DEVELOPMENT APPLICATION ASSESSMENT REPORT

Application Number:	DA2020/0432
----------------------------	-------------

Responsible Officer:	Phil Lane
Land to be developed (Address):	Lot 1 DP 847020, 9 - 11 Birdwood Avenue COLLAROY NSW 2097
Proposed Development:	Construction of a Seniors Housing or Housing for Persons with a Disability and Strata Subdivision
Zoning:	Warringah LEP2011 - Land zoned R2 Low Density Residential
Development Permissible:	Yes
Existing Use Rights:	No
Consent Authority:	Northern Beaches Council
Delegation Level:	DDP
Land and Environment Court Action:	No
Owner:	Birdwood Projects Pty Ltd
Applicant:	Birdwood Projects Pty Ltd

VIEW ANALYSIS
FIRST Floor
No.9 Brissenden Ave

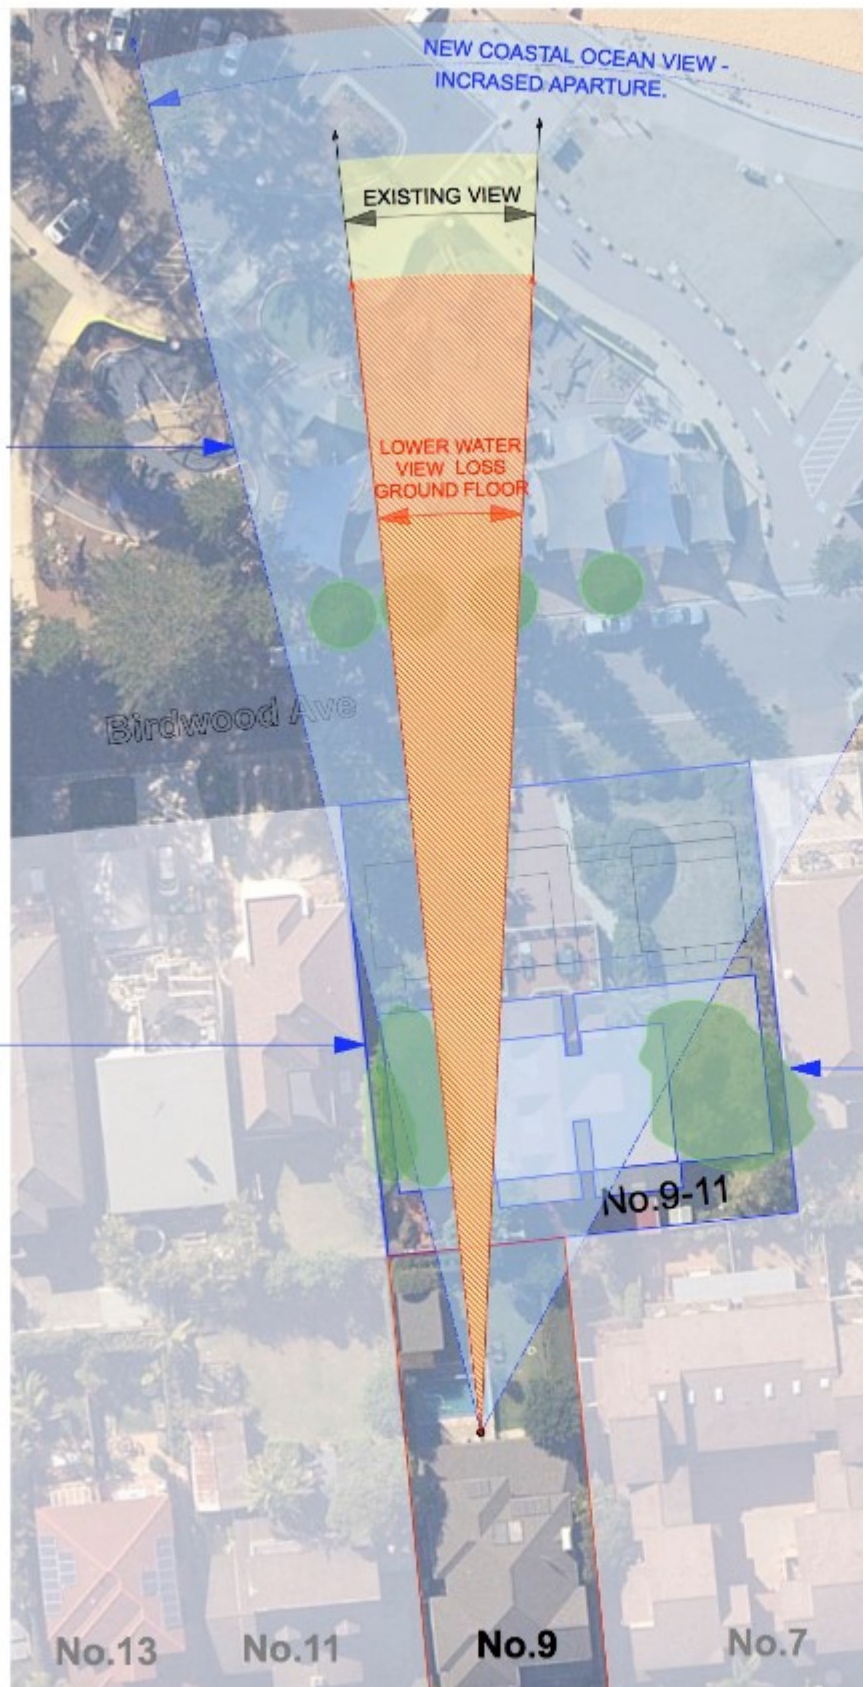
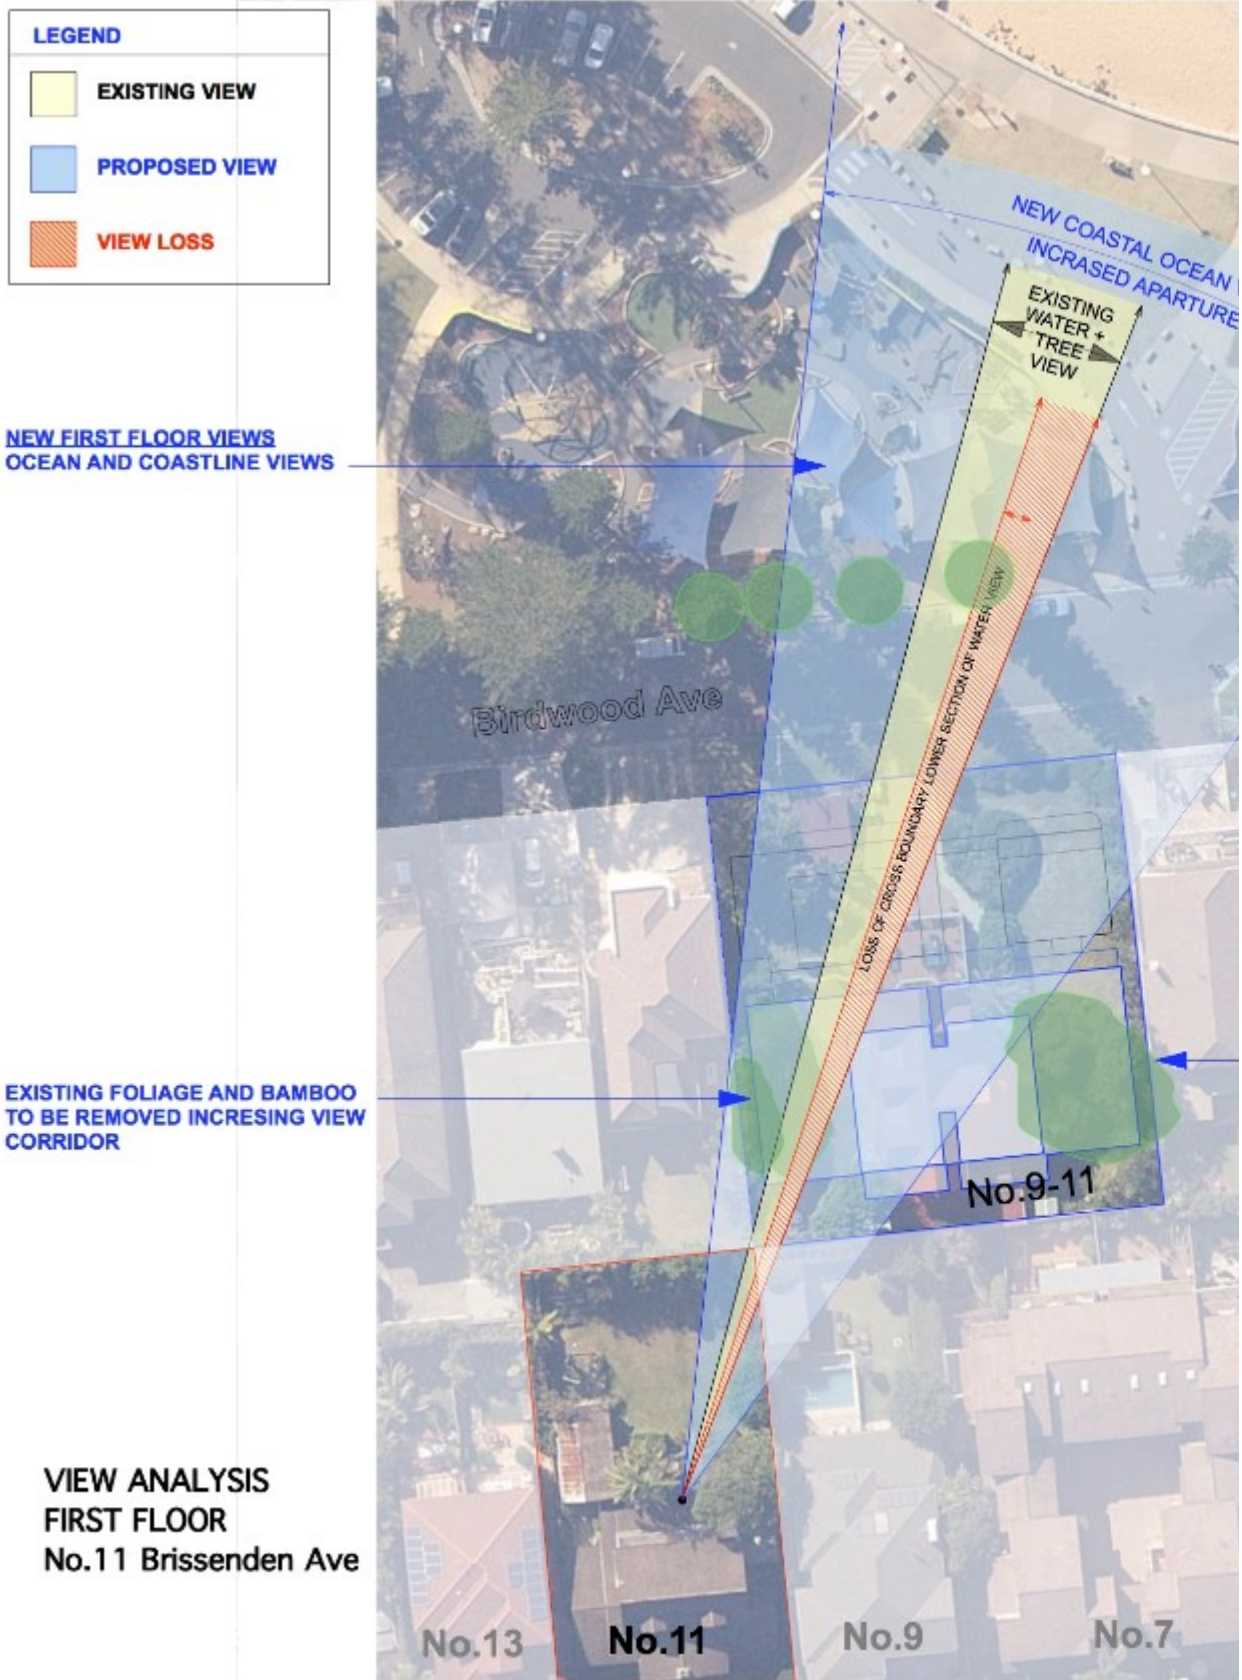
View analysis submitted by the applicant architect from No. 9 Brissenden Crescent.

View analysis submitted by the applicant architect from No. 11 Brissenden Crescent.

Viewing the amended plans and subject to the condition imposed by Council it is considered that the proposed development is acceptable and the view sharing is reasonable.
